City of Detroit
Inter-Departmental Communication

RE: Petition No. 1602
Requested Encroachment Into East 7mile Road at 11100 East 7 mile Road with
Concrete Barriers.

PROVISIONS FOR ENCROACHMENT For Petition 1602

**REQUEST BERM USE
 (Concrete Barriers)
 INTO E. 7 MILE RD.
 AT 11100 E. 7 MILE RD.**

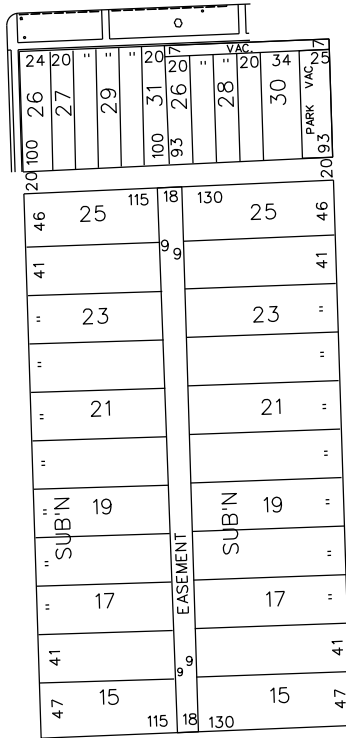
- DWSD has water main and sewer in the area of the requested encroachment. DWSD has no objections to the requested encroachments provided that the attached provisions for encroachment are strictly followed.

1. By approval of this petition the (DWSD) does not waive any of its rights to its facilities located in the right of way, and at all time, DWSD, its agents or employees, shall have the right to enter upon the right of way to maintain, repair, alter, service, inspect, or install its facilities. All costs incident to the damaging, dismantling, demolishing, removal and replacement of structures or other improvements herein permitted and incurred in gaining access to DWSD's facilities for maintenance, repairing, alteration, servicing or inspection caused by the encroachment shall be borne by the petitioner. All costs associated with gaining access to DWSD's facilities, which could normally be expected had the petitioner not encroached into the right of way shall be borne by DWSD.

2. All construction performed under this petition shall not be commenced until after five (5) days written notice to DWSD. Seventy-two (72) hours notice shall also be provided in accordance with P.A. 53 1974, as amended, utilizing the MISS DIG one call system.

3. Construction under this petition is subject to inspection and approval by DWSD forces. The cost of such inspection shall, at the discretion of DWSD, be borne by the petitioner.

4. If DWSD facilities located within the right of way shall break or be damaged as the result of any action on the part of the petitioner, then in such event the petitioner agrees to be liable for all costs incident to the repair, replacement or relocation of such broken or damaged DWSD facilities.

5. The petitioner shall hold DWSD harmless for any damage to the encroaching device constructed or installed under this petition, which may be caused by the failure of DWSD's facilities.
